Access Compliance Report

Public Rights-of-Way

(Curb Ramps)

Intersection ID: 43500	Main Street: MCALLISTER_PARK_DR	Cross Street: WILFORD_CT	Location: S
ADA ID: EE142266946F	Ramp Type: PerpDiag	Initial Pass/Fail: Fail	Overall Compliance: No
Severity Score: 8.75			
Codes/Mitigation Info/Possible Solution		Field Measurements/Component Compliance

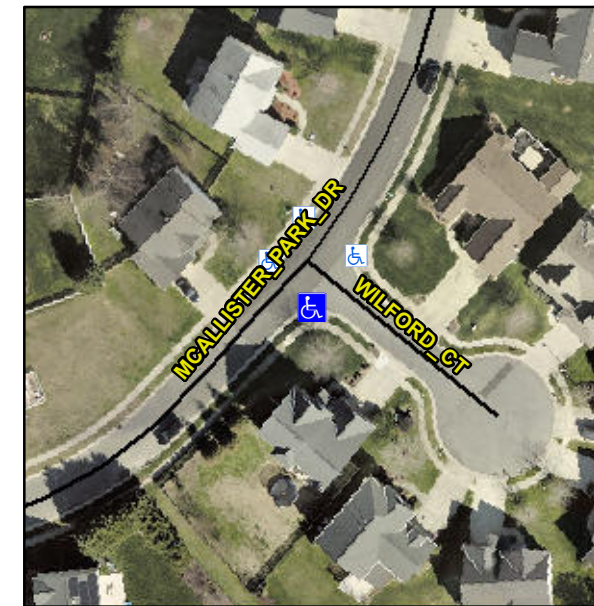
Not Found, R304.5.1

Compliance	Description	Data	Compliance	Description	Data
N/A	Ramp Length (in)	48.0	Yes	Ramp Slope (%)	5.8
No	Ramp Width (in)	37.5	Yes	Ramp XSlope (%)	0.4
N/A	Flare Type LT	N/A	N/A	Flare Type RT	N/A
N/A	Flare Slope LT (%)	N/A	N/A	Flare Slope RT (%)	N/A
N/A	Flare Traversable LT?	N/A	N/A	Flare Traversable RT?	N/A
N/A	Landing Length (in)	N/A	N/A	DWS Provided?	N/A
N/A	Landing Width (in)	N/A	N/A	DWS Contrast?	N/A
N/A	Landing Slope (%)	N/A	N/A	DWS Length (in)	N/A
N/A	Landing X Slope (%)	N/A	N/A	DWS Full Width?	N/A
N/A	Landing Curb? (Y/N)	N/A	N/A	DWS Offset (in)	N/A
N/A	Shared Landing?	N/A			
N/A	Gutter Ponding?	N/A	N/A	Gutter Slope (%)	N/A
N/A	Gutter Lip Ht (in)	N/A	N/A	Gutter X Slope (%)	N/A
N/A	Painted X Walk1?	No	N/A	Painted X Walk2?	No
	X Walk 1 Direction	To NE		X Walk 2 Direction	To NW
N/A	X Walk 1 Width (in)	N/A	N/A	X Walk 2 Width (in)	N/A
	X Walk 1 Slope (%)	3.4		X Walk 2 Slope (%)	0.9
	X Walk 1 X Slope (%)	5.0		X Walk 2 X Slope (%)	2.2

Remove & Replace Curb Ramp With Two New Directional Ramps or Equivalent.
